**Subject: Clutch Master Cylinder**

**Application: All 9000 Models**

CATEGORY		<b>Transmission</b>	
SECTION	<b>4</b>	PAGE	<b>12</b>
ISSUE	<b>05/93-0329</b>	CODE	<b>412</b>

**Figure 1.** Master Cylinder Replacement – 1989 and earlier.

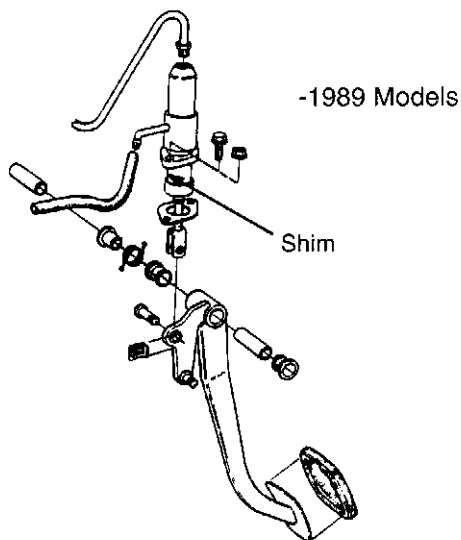
On -M89 cars (Figure 1), it is important to ensure that the cylinder is fitted straight relative to the pushrod. If the cylinder is not in alignment with the pushrod, adjust it by placing a 1mm shim between the front mounting lug and the bulkhead. Make sure that the cylinder is sealed against the bulkhead after adjustment.

**Figure 2.** Master Cylinder Replacement – 1990 Models and later.

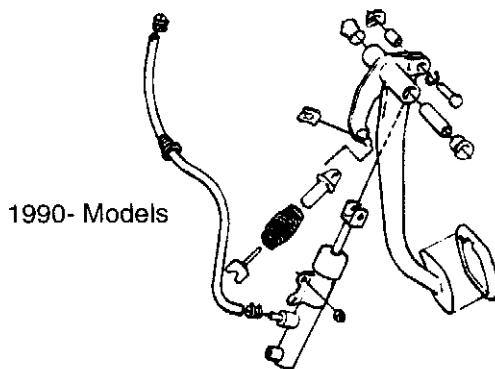
On M90- cars (Figure 2), be sure to properly lubricate the pedal pivot. Also refer to PSI 07/90-0012 "Clutch Pedal Return" for further information.
